STATE OF VERMONT AGENCY OF TRANSPORTATION

PROPOSED IMPROVEMENT BRIDGE PROJECT TOWN OF HARTLAND COUNTY OF WINDSOR

RECORD PLANS	
CONTRACTOR:	KUBRICKY CONSTRUCTION CORP. - WILTON, NY
RESIDENT ENGINEER:	DARYL BASSETT
CONSTRUCTION BEGAN:	JUNE 10, 2014
CONSTRUCTION COMPLETE:	NOVEMBER 5, 2014
RECORD PLANS BY:	DARYL BASSETT & KEVIN KING
I HEREBY CERTIFY THAT ALL THE CONSTRUCTION REQUIRED BY THIS SET OF DRAWINGS HAS BEEN ACCOMPLISHED AS INDICATED HEREIN.	
BY	RESIDENT ENGINEER
DATE	2/22/16
NOTE: Any further information concerning final quantities, amounts or other details relative to this project may be found by contacting Vtrans Records Management.

US ROUTE 5 (MAJOR COLLECTOR), BRIDGE NUMBERS 62A AND 66

**WINGWALL 2 ELEVATION**  
SCALE 1/2" = 1'-0"

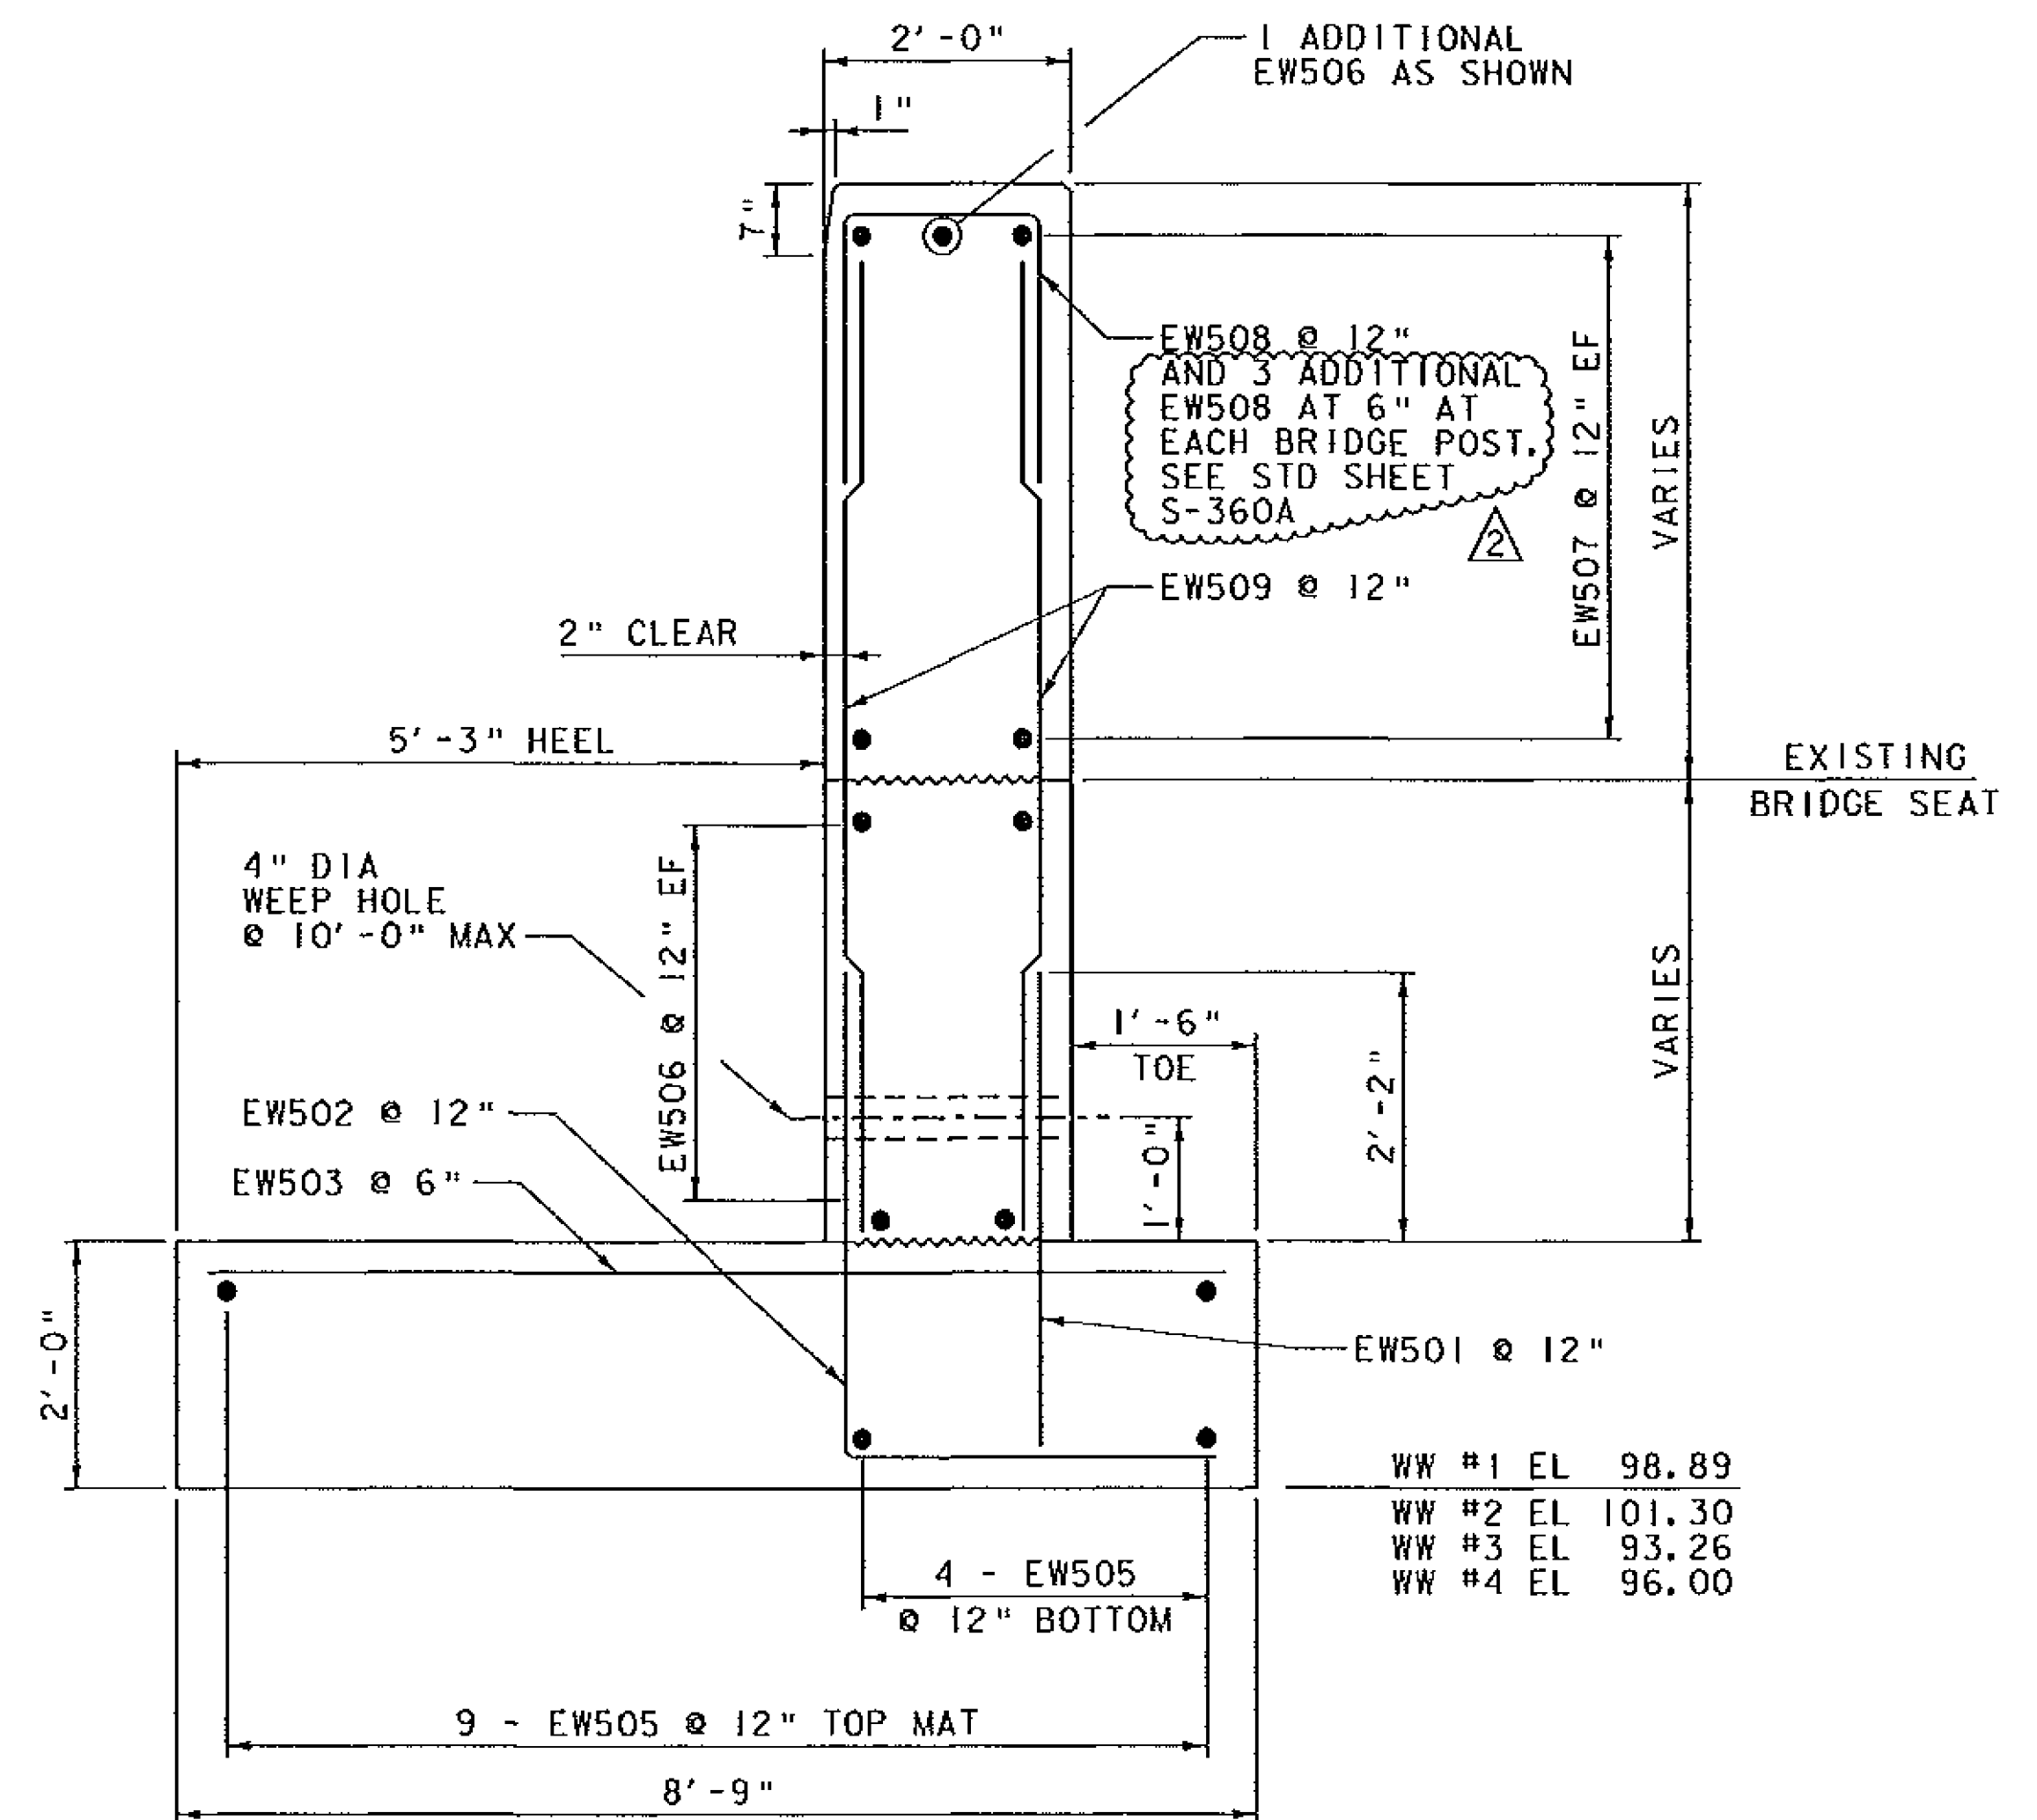
REV.	DESCRIPTION	DATE
△	ADDITIONAL EW508 AT POSTS	3/3/2014
PROJECT NAME: HARTLAND		
PROJECT NUMBER: BHF BPNT(12)		
FILE NAME: z:\c260sub.dgn		PLOT DATE: 3/3/2014
PROJECT LEADER: M.A. COLGAN		DRAWN BY: A.J. GOUDREAU
DESIGNED BY: A.J. GOUDREAU		CHECKED BY: S.G. FARNSWORTH
BR 62A WINGWALL DETAILS (1 OF 2)		SHEET 28 OF 55
